CANBY PLANNING COMMISSION

DR 92-02, a request by Wildflower Properties, Inc. (Ron Bohart) for approval of a Site and Design Review application for the construction of a four-plex residence on a 12,500 square foot lot located on the south side of S.W. 3rd Avenue, west of S. Ivy Street (Tax Lot 6500 of Tax Map 3-1E-33CD).

- STAFF REPORT -

DR 92-02

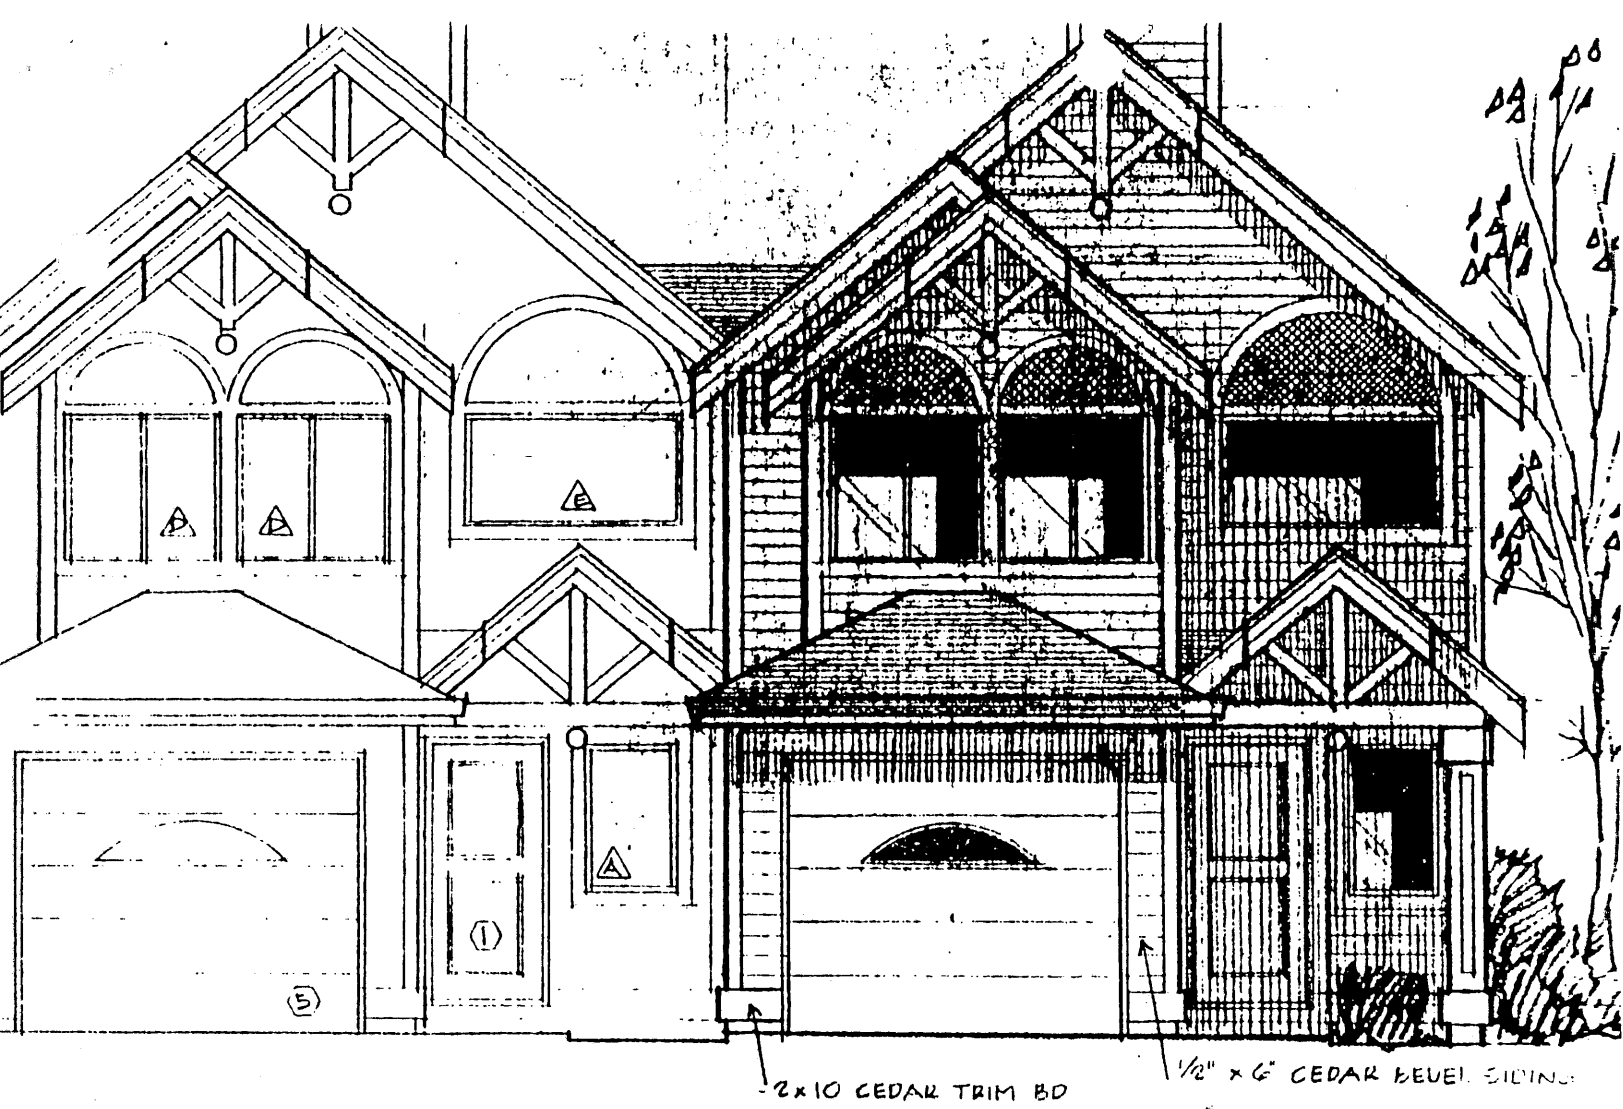
The type of maple trees proposed for the north property line have not been identified and could hinder solar access for the neighboring residential lot to the north.

Access for vehicles to the four-plex is from S.W. 3rd Avenue. The access drive meets the ordinance requirement of a minimum of 20 feet wide from S.W. 3rd Avenue. Two five-foot landscaped strips will border the access drive. Two existing fir trees, within the landscaped strips, will also border the access drive. A curb cut for the driveway and a sidewalk are not present along S.W. 3rd Avenue.

Utilities are available in the vicinity. A sewer lateral exists in the driveway, but it services an adjoining lot and does not have the capacity to service this proposal. A new lateral will need to be constructed to service this proposal. Since the proposed four-plex is on a flag lot which is more than 250 feet from an existing hydrant, a new hydrant will need to be installed at the entrance of the access driveway from S.W. 3rd Avenue.

From The Property CORNER ON THE WEST CORNER OF
Lot 6. There is a Sewer LATERAL 10 Feet West
into Lot 5. This Sewer Service is For
Lot 2. Another Sewer Service will be needed
For this 4-plex on Lot 5. With
Sidewalk joining Lot 5 From Lot 6 The
sidewalk should be extended To Lot 3 at
Developer expense.

- * There doesn't appear to be a lateral. There may be a "Y" but it would be just luck if we found it so the applicant should plan on the expense of a lateral.
- " 3rd street is narrow so be sure there is adequate off street parking.
- * Over the years, there has been interest in developing this piece but I am not certain why nothing has happened
- * A concrete approach should be required for the driveway and be designed as a sidewalk even though there is only 30 feet

Owner applicant please a 6' fence
along the North side property line.
Plus 6' fence along drive entrance
on the westside property line.

1. That the maple trees planted on the north side of the property shall be of the type listed as "solar friendly".

2. A hydrant shall be installed at the entrance of the access driveway from S.W. 3rd Avenue, according to Canby Utility Board specifications.
3. Access driveway shall be constructed and covered with an all-weather surface material prior to construction of dwellings. A gravel driveway is an acceptable surface for this purpose, prior to and during the construction of the dwellings.
4. A concrete approach for the access driveway, designed as a sidewalk, shall be constructed for the property frontage along S.W. 3rd Avenue.
5. A new sewer lateral shall be connected to the sewer line in S.W. 3rd Avenue.
6. Addresses for the four-plex shall be displayed at the access driveway entrance from S.W. 3rd Avenue.
